ADDENDUM NUMBER ONE
CAMDEN PUMP STATION IMPROVEMENTS
CONTRACT B
VILLAGE OF CAMDEN, HILLSDALE COUNTY, MICHIGAN
PROJECT NO. 10E04319
NOVEMBER 13, 2007
BID OPENING: NOVEMBER 20, 2007 AT NOON

ADDENDUM # E1

STANDARD METAL FENCE DETAIL

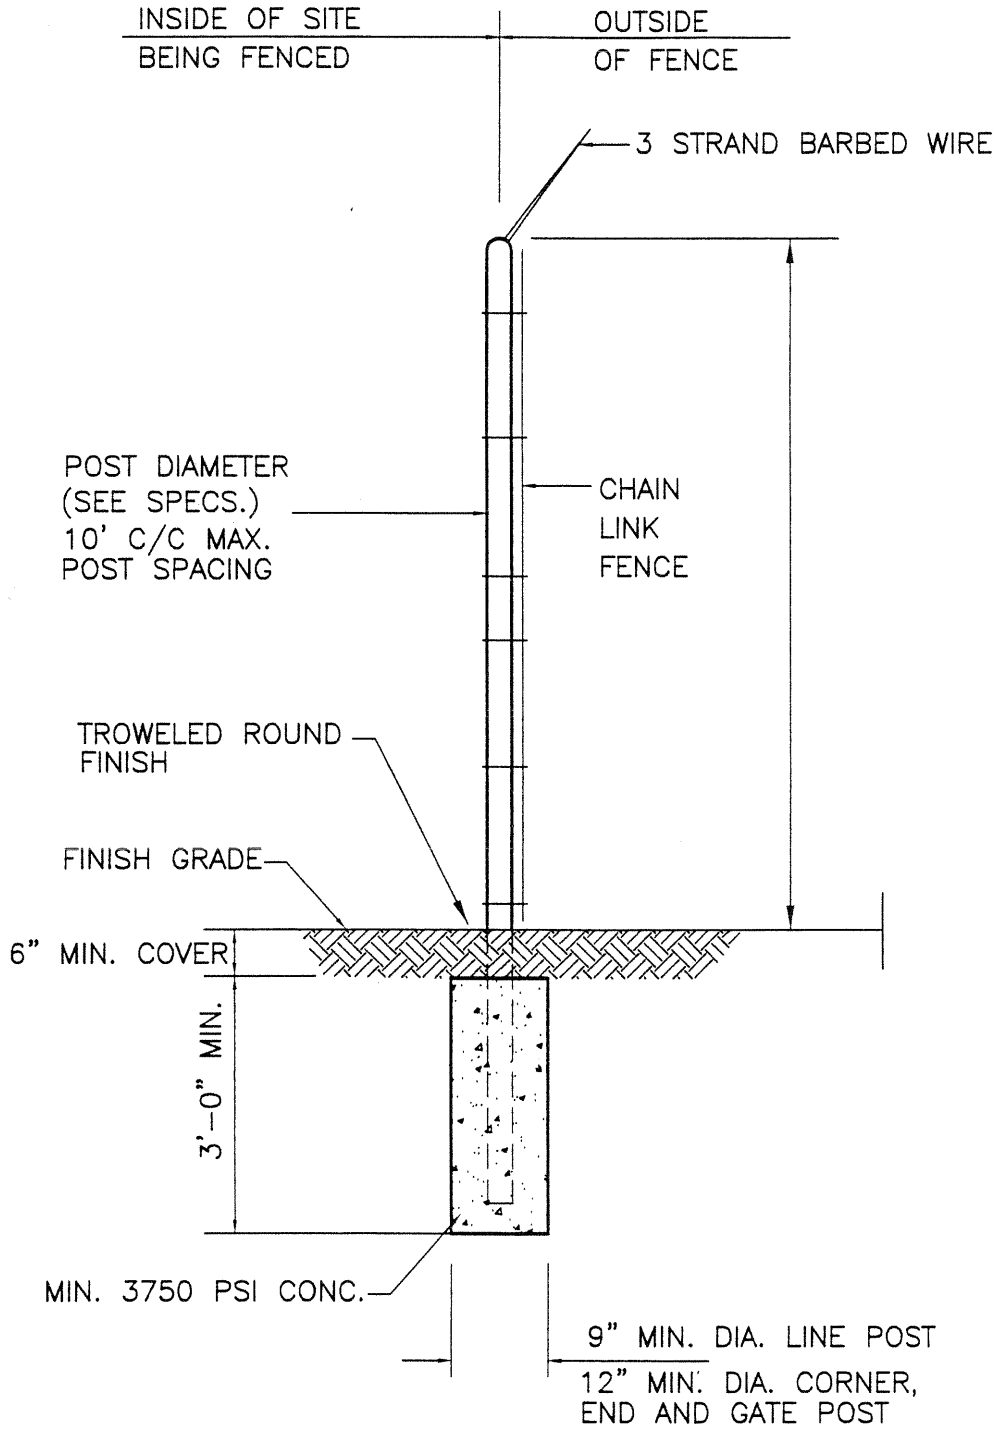
Sheet 6

Add the attached **STANDARD METAL FENCE DETAIL**

In Section 02830-1 Fencing and Gates, Item 2.01A shall be changed to read as follows: “**All new fencing required to provide the enclosures shown on the Drawings shall have a fence height of six (6) feet not including the three (3) rows of barbed wire on forty-five degree (45 °) “V” shaped vertical extension arms. Fencing shall be in accordance with the detail shown on the Drawings**”.

In Section 02830-1 Fencing and Gates, Item 2.01F shall be changed to read as follows: “**“V” shaped extension arms supporting barbed wire shall be galvanized, inclined at forty-five degrees (45 °), and shall be capable of supporting a weight of 250 lbs. applied vertically at the tip. Install three (3) rows of two strand barbed wire consisting of 12-1/2 gauge wire with 14 gauge 4 point barbs spaced five (5) inches apart.**”
